Official Transcript of Proceedings
NUCLEAR REGULATORY COMMISSION

Title: Advisory Committee on Reactor Safeguards
AP1000 Subcommittee: OPEN SESSION

Date: Thursday, July 22, 2010

AP1000 SUBCOMMITTEE

Potential Quaternary Features in the VCSNS Site Region (AFSER Figure 2.5.1-2 after FSAR Figure 2.5.1-215)

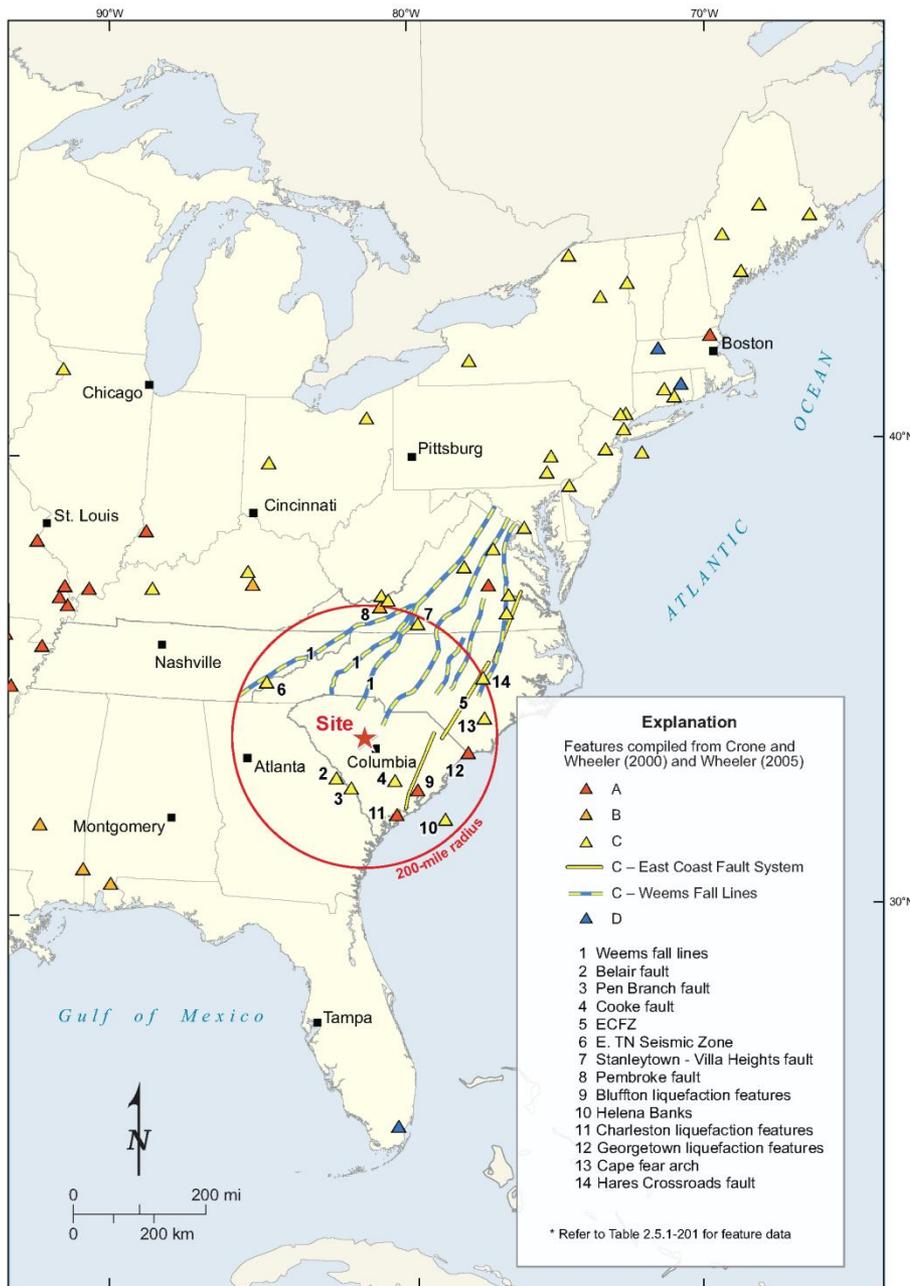
- **Capability of tectonic structures mapped in the site region, site vicinity, and site area**
 - Issue: Ensure that no potentially-capable tectonic faults (i.e., faults of Quaternary age, 2.6 million years ago [Ma] to present) have been mapped in the site region, site vicinity, or site area.
 - Applicant identified 14 potential Quaternary tectonic features in the site region (i.e., potentially capable tectonic structures with possible associated seismic hazard).
 - No mapped tectonic structure to which the 1886 Charleston area earthquake can be associated has been identified. Charleston area is characterized as a seismic source zone for assessment of seismic hazard (AFSER Section 2.5.2).

Updated Charleston Seismic Source (UCSS) Model (FSAR Figure 2.5.2-213)

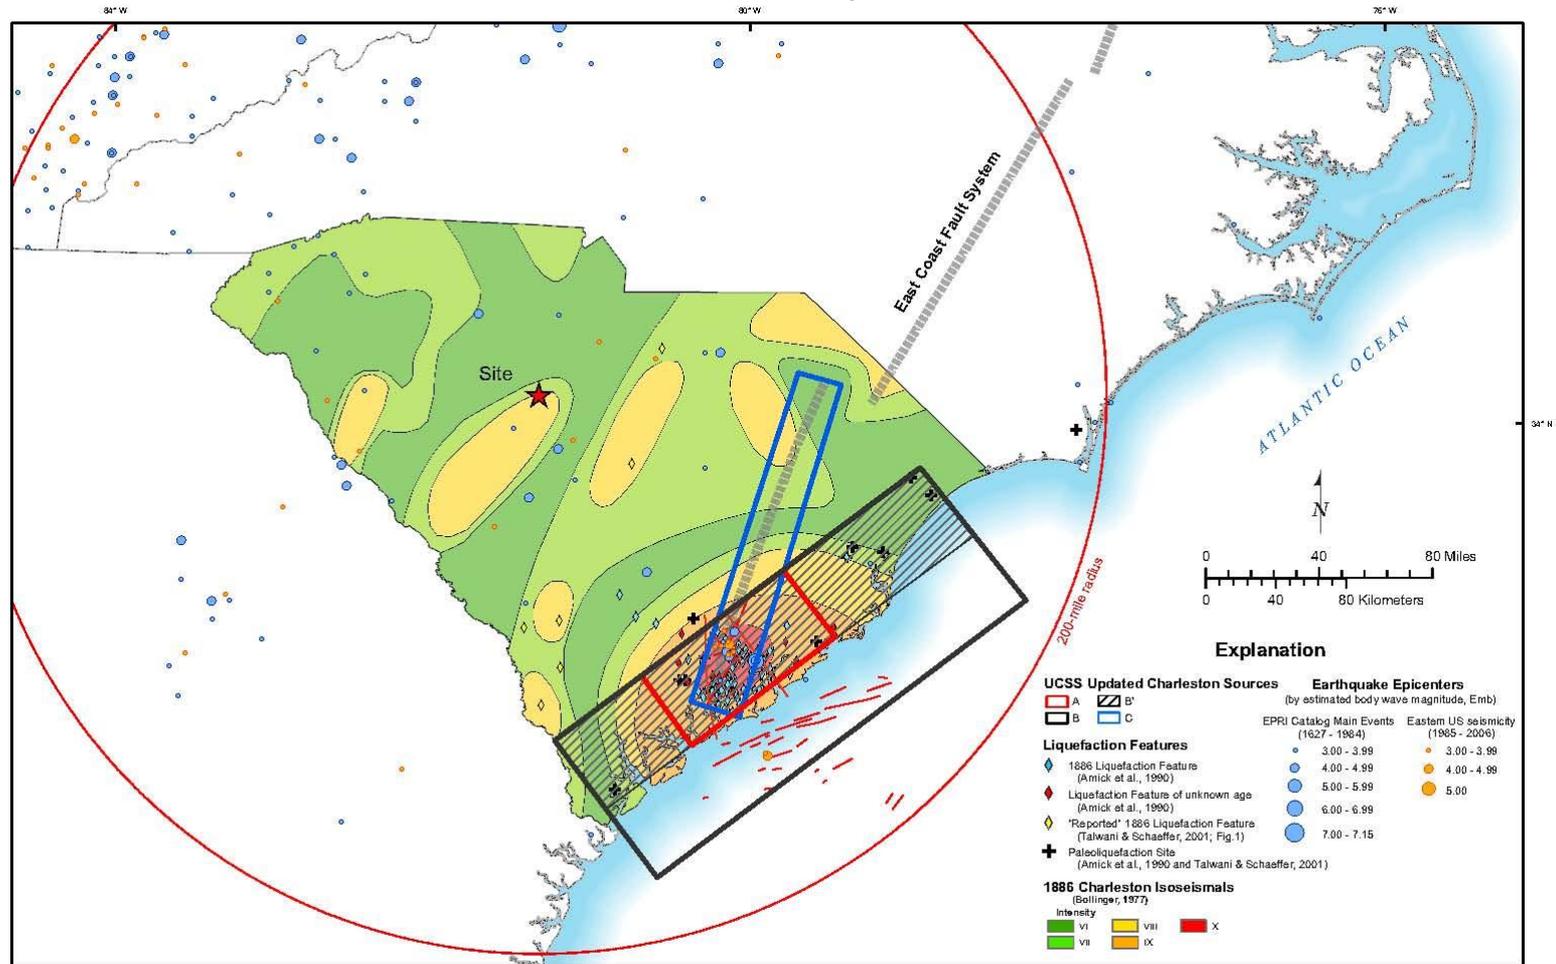
- Issue: Applicant updated the original 1986 EPRI Charleston seismic source models with the UCSS model originally presented in the SSAR for the Vogtle ESP site (SNC, 2008).
 - Staff asked applicant to address a newly-reported Charleston area paleoliquefaction feature (Talwani and others, 2008) in regard to the UCSS model.
- Resolution: Talwani and others (2008) estimated a magnitude of about 6.9 for the causative earthquake, which falls within the M_{\max} range captured in the UCSS model, and the newly-reported paleoliquefaction feature lies within one of the source area geometries defined for the UCSS model.

Comparison of ETSZ M_{max} distributions from EPRI-SOG, TIP, and TVA Dam Safety Studies (AFSER Figure 2.5.2-13)

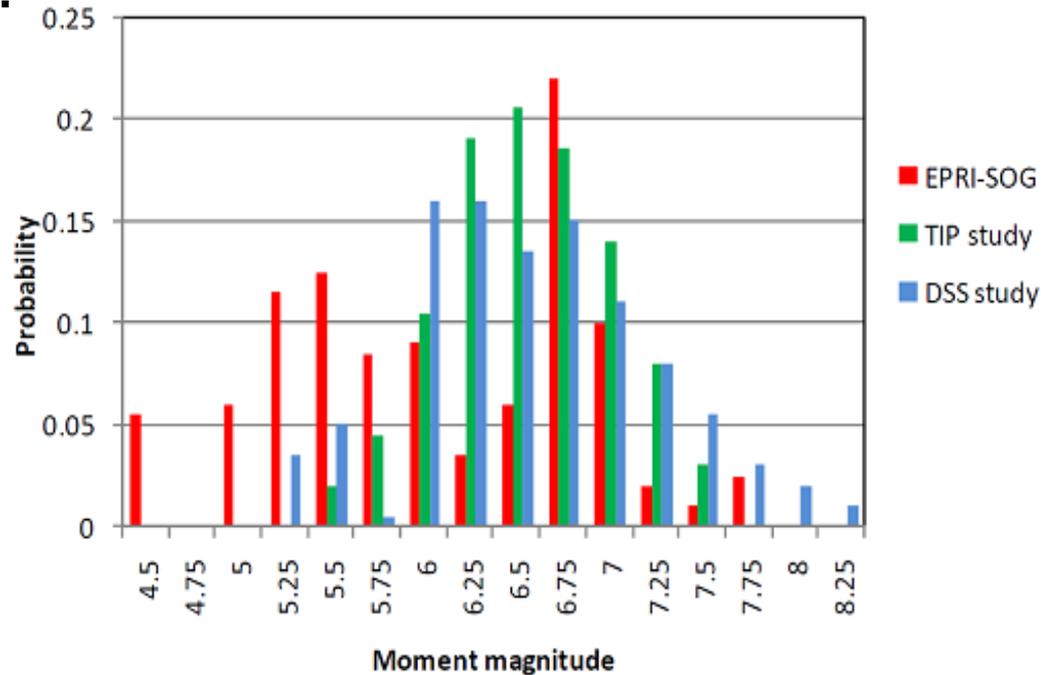
- **Eastern Tennessee Seismic Zone (ETSZ)**
 - Issue: Applicant did not include newer ETSZ source models that post-date the 1986 EPRI study in the VCSNS PSHA.

V. C. Summer Site Vicinity
Tectonic Features Map
(AFSER Figure 2.5.3-1 after
FSAR Figure 2.5.1-212)

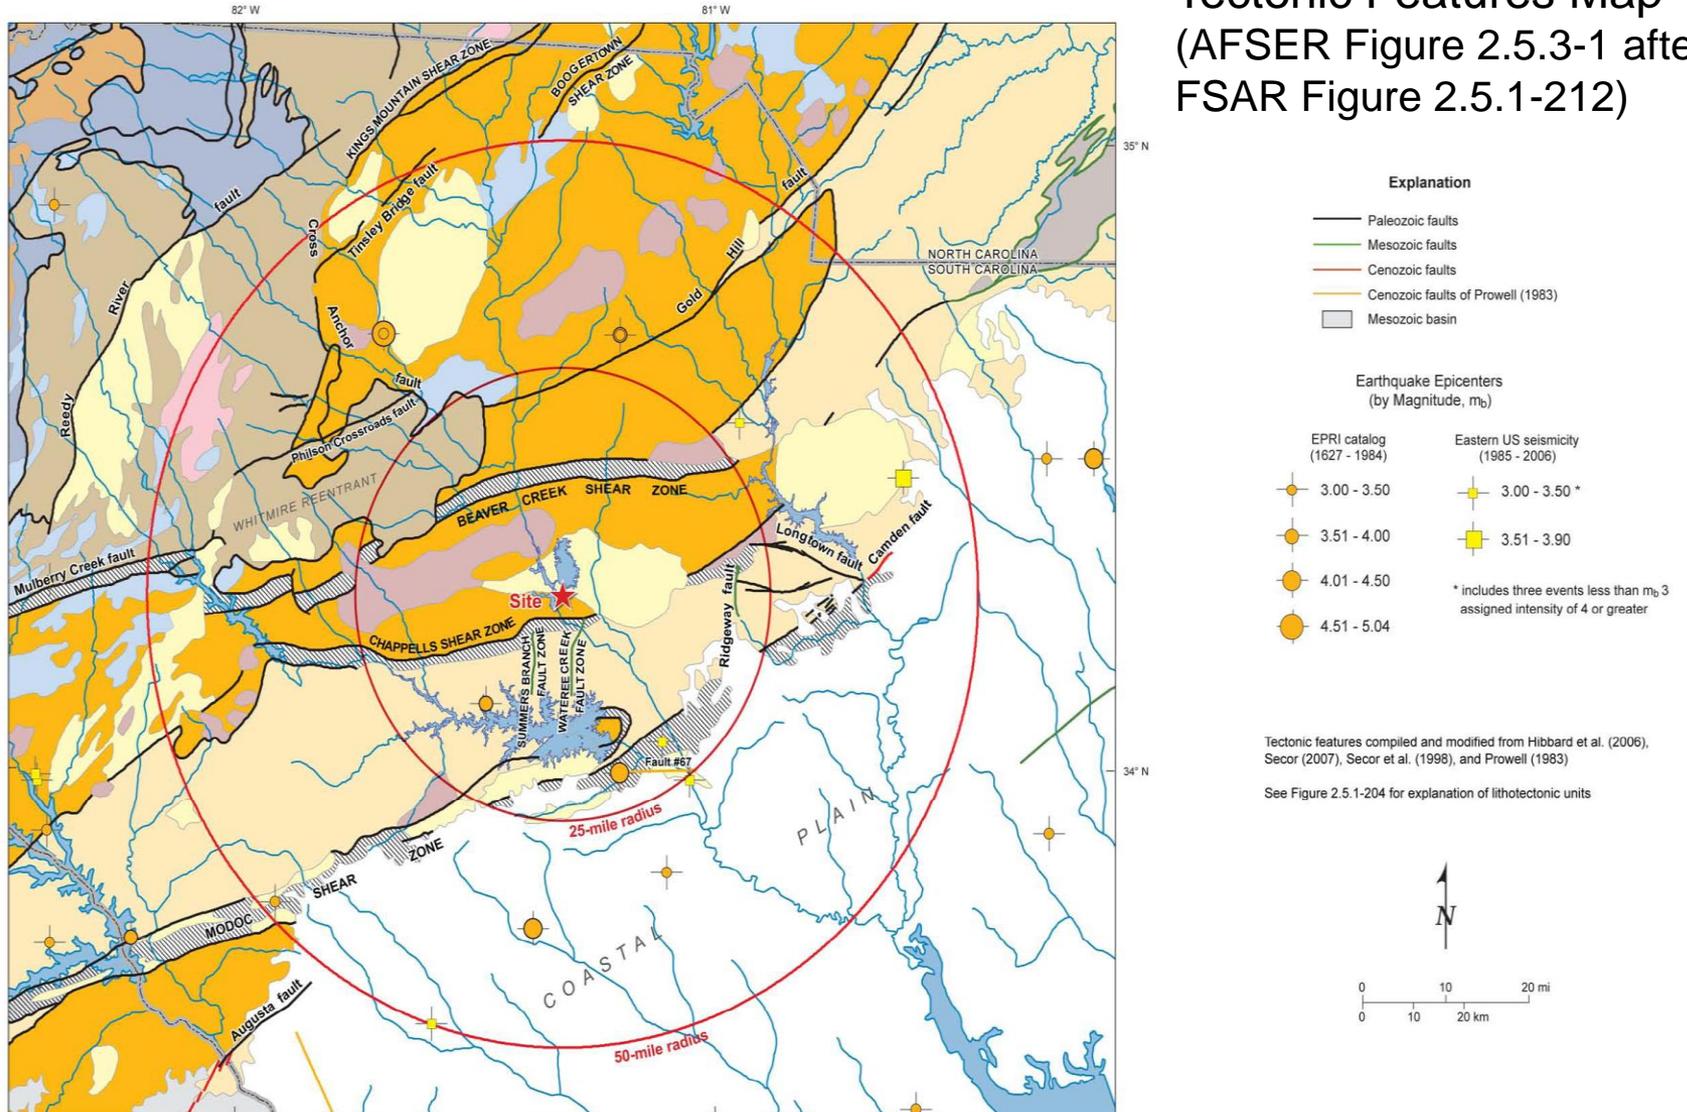
- **Surface Faulting in the Site Vicinity & Site Area**
 - Issue: Ensure that no capable surface or near-surface tectonic faulting exists in the site vicinity and site area.
 - Applicant documented that tectonic surface structures have been mapped in the site vicinity.
 - Resolution: Staff’s review of detailed responses to RAIs resolved concerns related to occurrence of capable surface or near-surface faulting in the site vicinity and site area.
 - Staff found that information (i.e., constraining field relationships and radiometric age dates) provided by the applicant documented that no surface or near-surface Quaternary tectonic faults occur in the site vicinity or site area.
 - Non-tectonic surface or near-surface deformation is not expected because of the physical properties of crystalline bedrock in the site vicinity and site area and at the site.
